FILE INFORMATION:
DIVISION TAB-TRANE REFRIGERATION
PRODUCTS
PRODUCT TAB-RECIPROCATING COM-
PRESSOR-CONDENSER
UNITS
MODEL TAB-HERMETIC E-F
LITERATURE ITEM-GENERAL SERVICE
BULLETIN

HCOM-SB-28A

**GENERAL
SERVICE BULLETIN**

SUBJECT: MODEL E OPEN AND HERMETIC COMPRESSOR, LUBRICATION DESIGN CHANGE

FIGURE 1

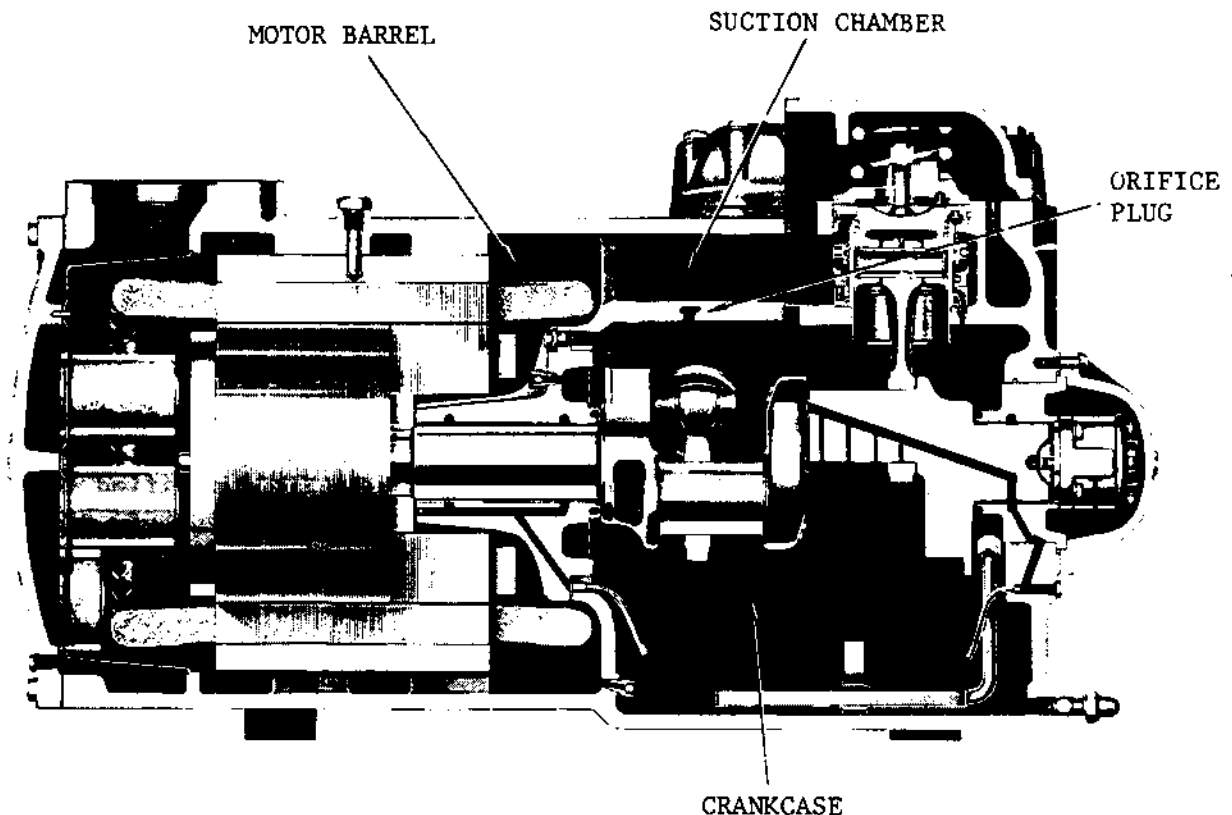
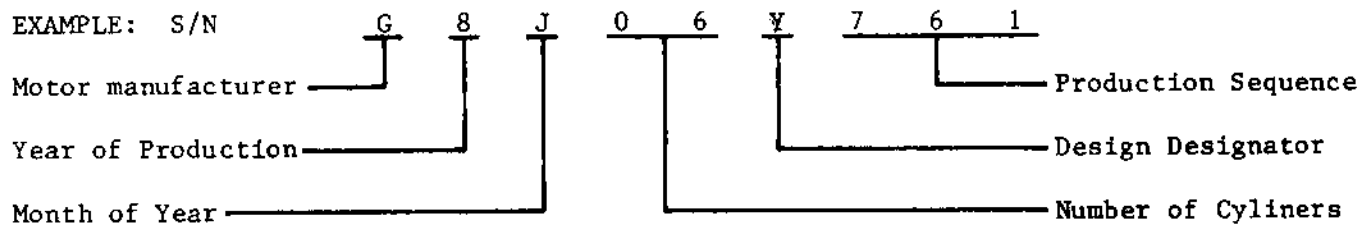
The oil return system of all Model "E" compressors was changed to replace the oil return check valve with a stand pipe and to replace the cylinder bank oil drain check valves with orificed plugs.

The use of orifice plugs instead of check valves between the crankcase and suction chamber provides more positive venting to keep the pressure in the crankcase at a lower pressure than the motor barrel. (See Figure 1). The flow of suction gas from the motor barrel cavity to the suction chamber causes a corresponding pressure drop, with the pressure in the suction chamber being lowest. Normal compressor crankcase pressure will be approximately 2" W.C. lower than the motor barrel pressure at minimum load to approximately a 5" W.C. differential at full load.

The stand pipe prevents oil migration from the crankcase to the suction chamber (motor barrel) during the compressor off cycle.

FIGURE 2

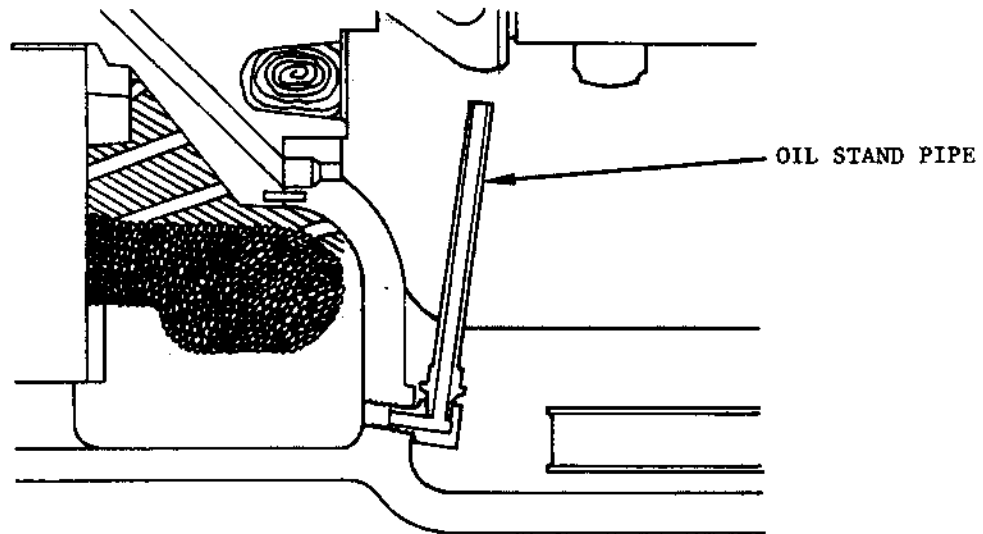
On the Hermetic Compressor, the oil return check valve should be removed and replaced with an oil stand pipe tube assembly and street elbow (See Figure 2). The two upper ball check valves should also be replaced with oil drain orifices (See Figure 3).

Figure 2 illustrated the oil stand pipe for Model E Hermetic only. The open version has a 1/2" coupling and elbow located closer to the crankshaft.

Street elbow	ELL-125	1 required
Tube assembly	PIP-164	1 required
Oil drain orifice	PLU-174	2 required

FIGURE 3

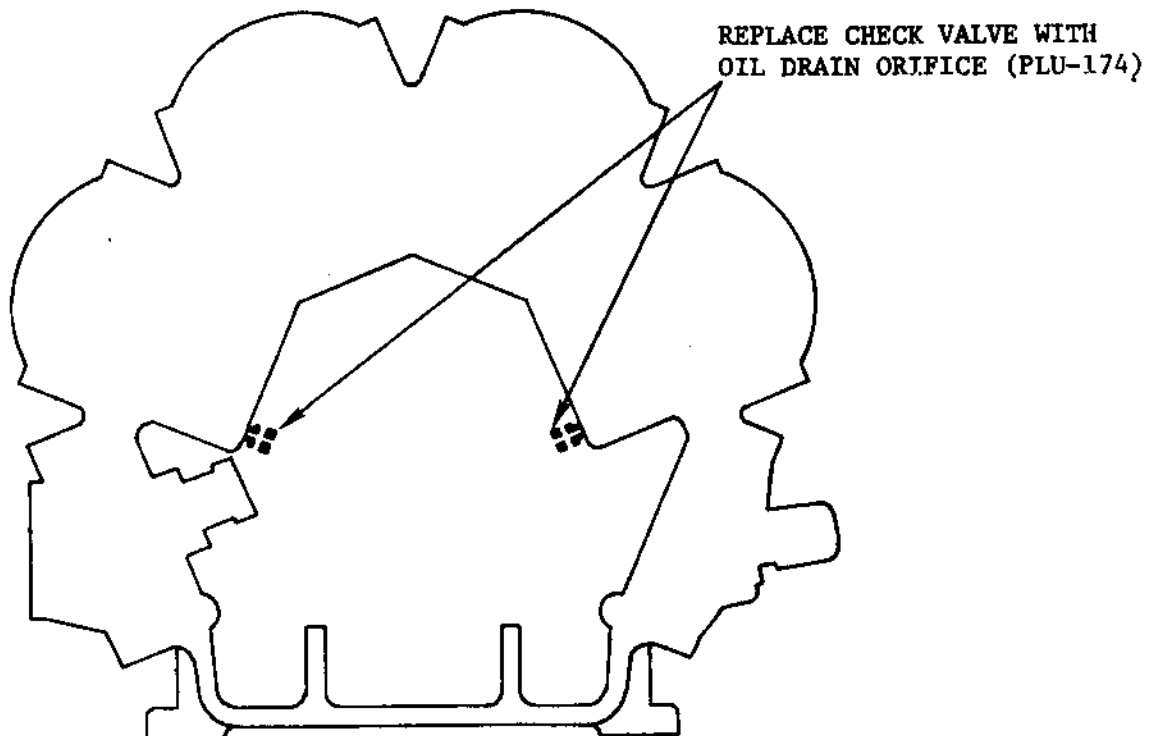
On the Open Compressor, the oil return check valve should be removed and replaced with a street elbow and coupling half union. The two upper ball check valves should also be replaced with oil drain orifices (See Figure 3).

FIGURE 4

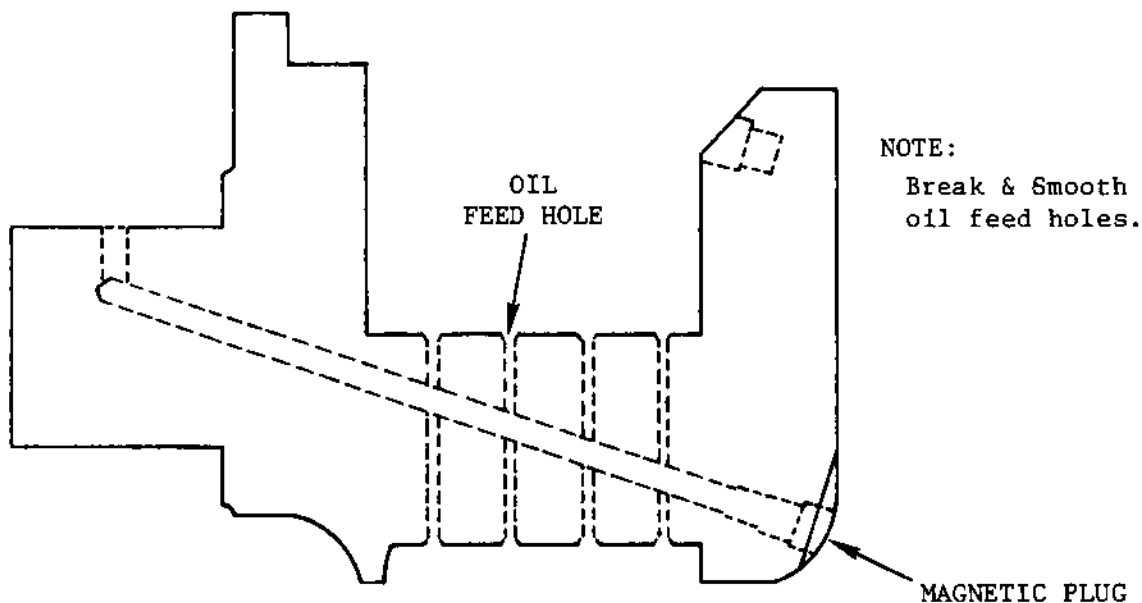
Crankshaft Crankpin Oil Feed Holes

When rebuilding previous design sequence compressors, oil feed holes should be drilled through the crankshaft (See Figure 4). This can be accomplished with an industrial high speed drill bit. Use the present oil feed holes in the crankshaft as pilot holes. Drill the holes through with a 1/8" drill then redrill with a 3/16" drill. After the holes have been drilled through, break and smooth the oil feed holes with a 45° chamfer using a countersink drill or equivalent. After the drilling has been completed, lightly polish the crankshaft journal with crocus cloth to remove any burrs or nicks. Remove the magnetic plugs and wash the crankshaft with solvent, then blow out any filings that remain in the oil feed passages with compressed air or nitrogen.
